## Determination 2009/81

# Dispute over a building consent for alterations to a house due to the slope of the roof at Riverside Village 25, Glenavy

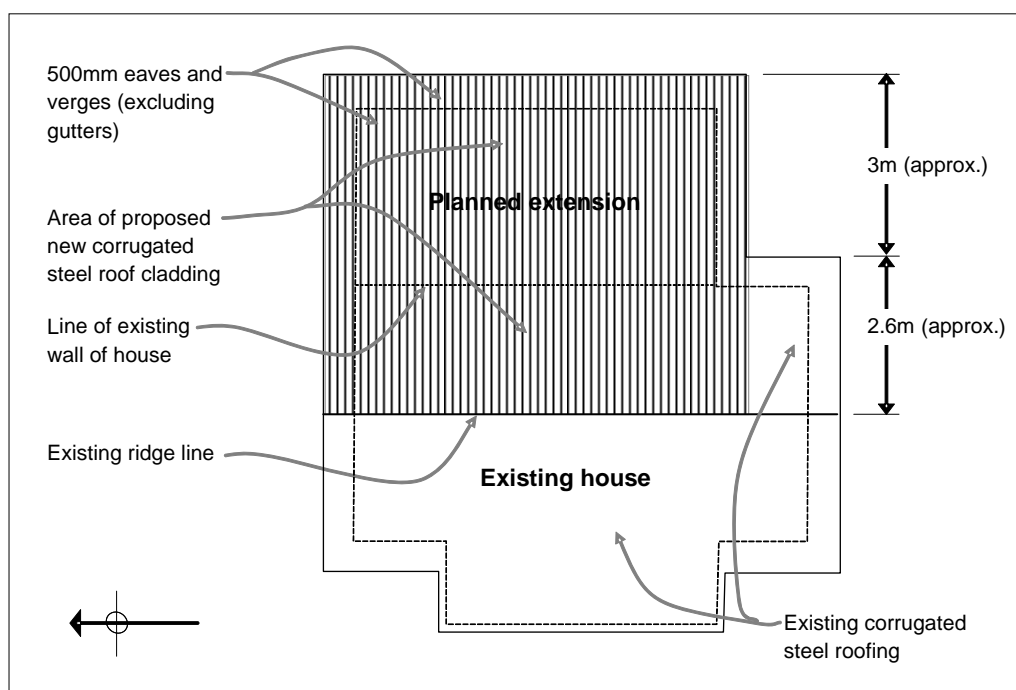
- 2.3.1 The existing roof cladding is corrugated galvanised steel at 6° pitch; and a 3 metre extension to the east is proposed as shown below:

- 2.3.2 The proposed work will include the replacement of the existing roof back to the ridge flashing. The roof cladding originally proposed for the extension was to match the existing cladding with respect to material, profile, side laps and pitch. The eaves and verge projections to the extension will be 500mm (excluding gutters) to match the existing roof.

- 8.1 In accordance with section 188 of the Building Act 2004, I hereby determine that the roof material originally proposed for the extension to this building will comply with Clause E2 of the Building Code.
